SUNDRY NOTICES AND REPORTS ON WELLS
Do not use this form for proposals to drill or to re-enter an abandoned well. Use Form 3160-3 (APD) for such proposals.

8. Well Name and No. FORTY NINER RIDGE UNIT/131H

Mewbourne Oil Company requests approval to make the following changes to the approved APD:

PECOS DISTRICT DRILLING CONDITIONS OF APPROVAL

3-String Design – Open Production Casing Annulus

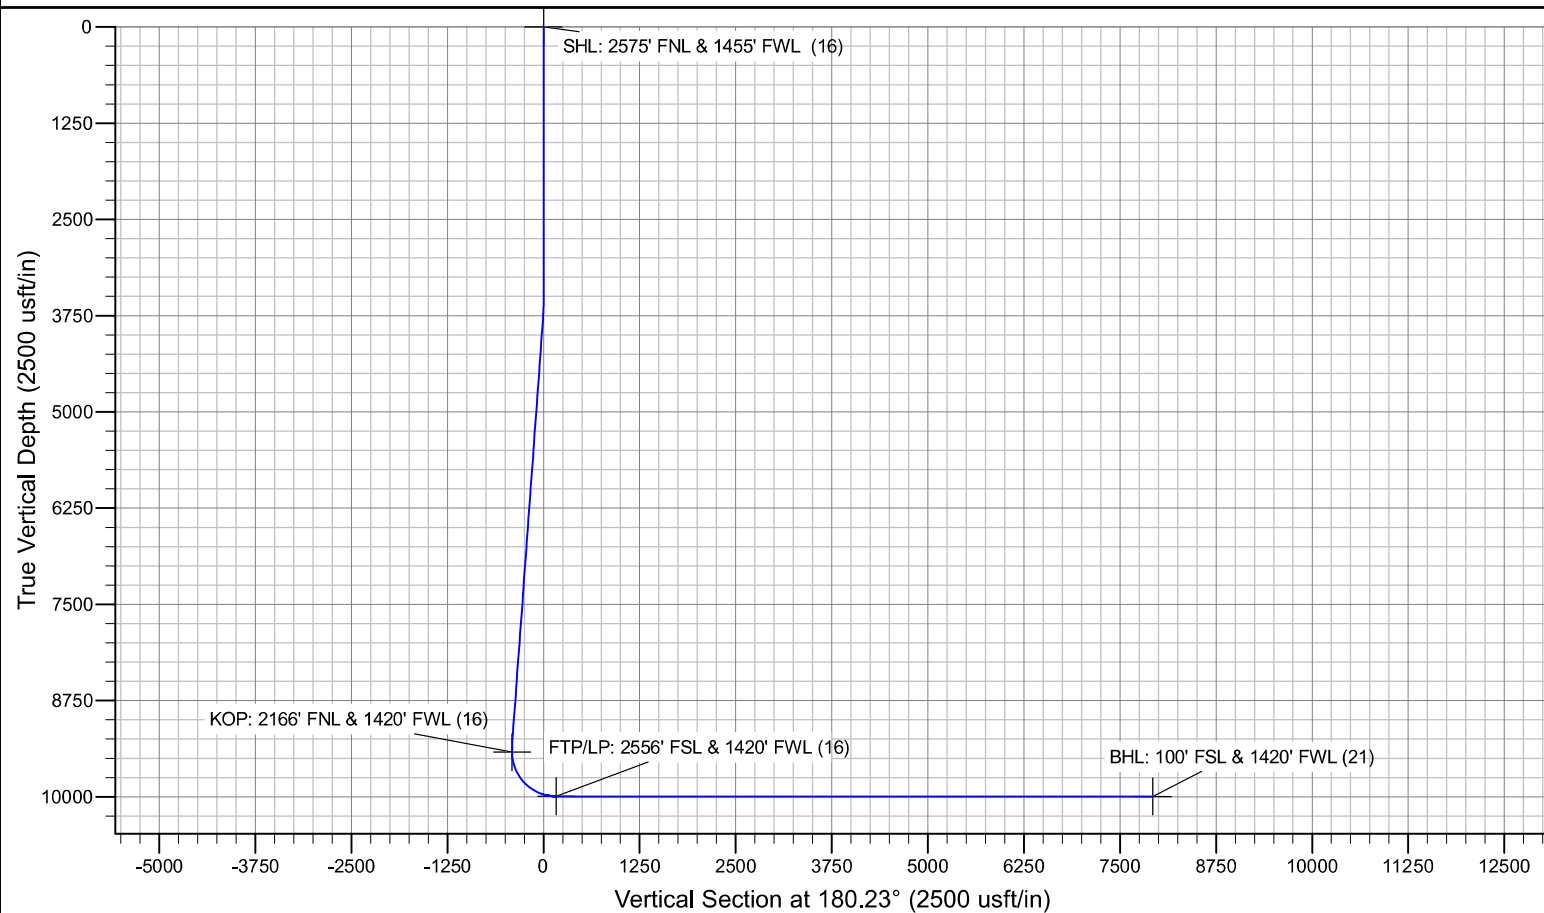
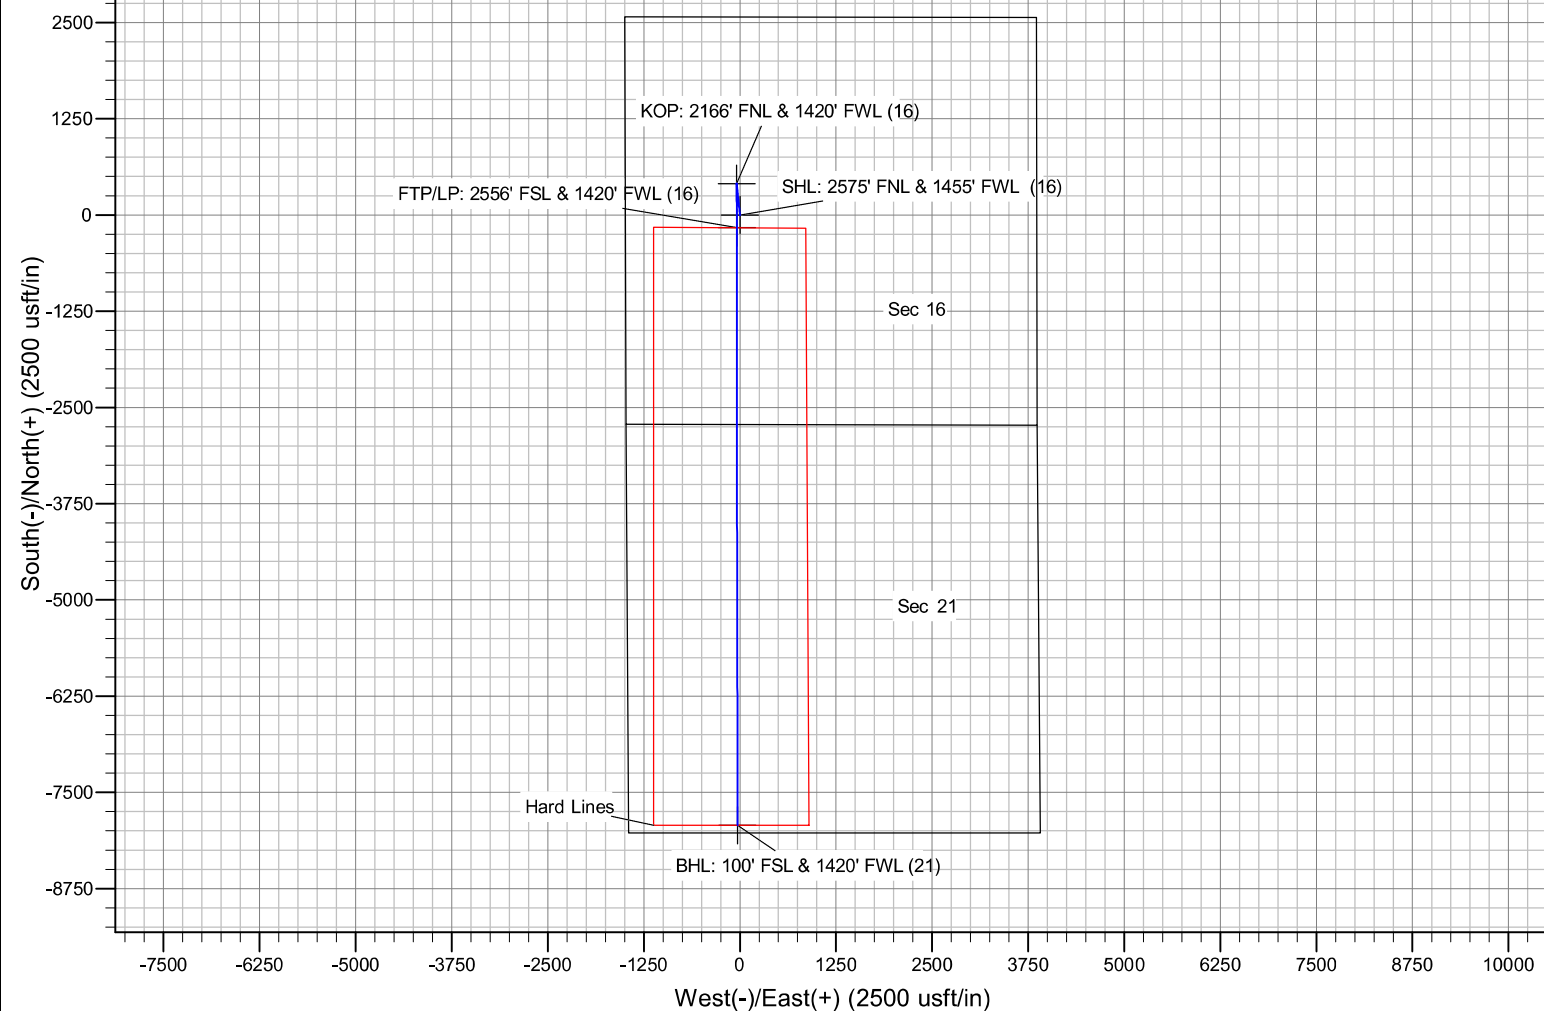
Mewbourne Oil Company request a variance for the production string per R-111P guidelines to be implemented as follows:

- b) For wells within the KPLA where a 2nd intermediate string will not be utilized resulting in a 3 String Design (Surface, Salt or Salt/Capitan Reef, Production), the following safeguard shall apply to safely divert flow of wellbore fluids away from the Salt Interval in the event of a catastrophic production casing failure. The Surface Equipment utilized during stimulation operations should be designed to relieve pressure from the production x intermediate casing annulus below the burst threshold of the casing string components.

- i. A monitored open annulus will be incorporated during completion by leaving the 1st Intermediate Casing x Production Casing annulus un-cemented and monitored inside the 1st Intermediate String. Reference wellbore diagram.

- i. The top of cement in the Production Casing x 1st Intermediate Casing Annulus shall stand uncemented at least 500' below the 1st Intermediate Casing Shoe. Zero percent excess shall be pumped on the Production Cementing Slurry to ensure no tie-back into the 1st Intermediate Casing Shoe.

- ii. After Stimulation Operations have been concluded and no longer than 180 days after the well is brought online, the operator will be responsible for Bradenheading cement to ensure at least a 500' tie back has been established inside the 1st Intermediate (Salt String / Capitan String) but not higher than Marker Bed No. 126 (base of the Potash mining interval).

WELL LOCATION AND ACREAGE DEDICATION PLAT

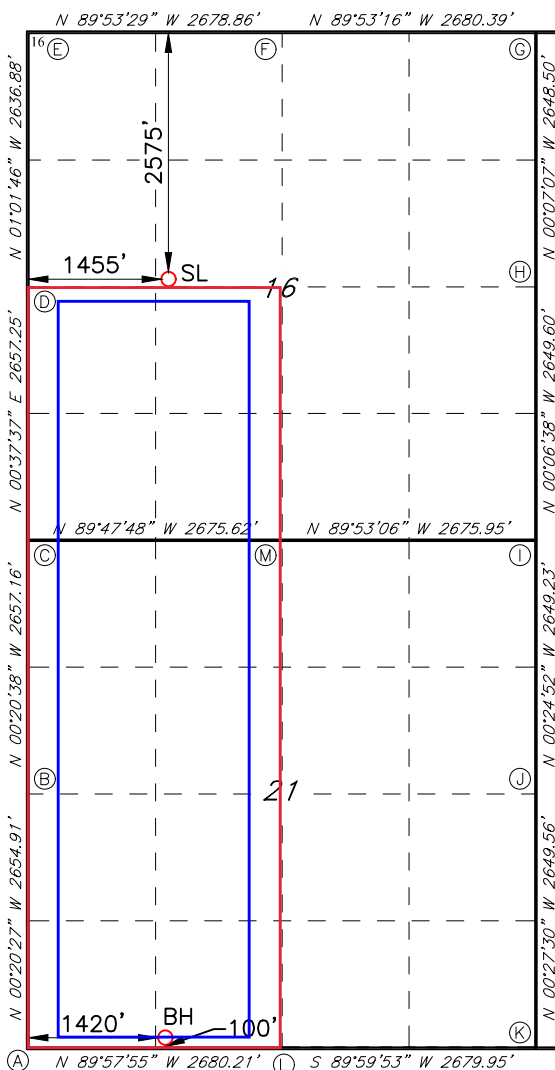
1) Change SHL from 2575' FNL & 1395' FWL, Sec 16, T23S, R30E to 2575' FNL & 1455' FWL, Sec 16, T23S, R30E
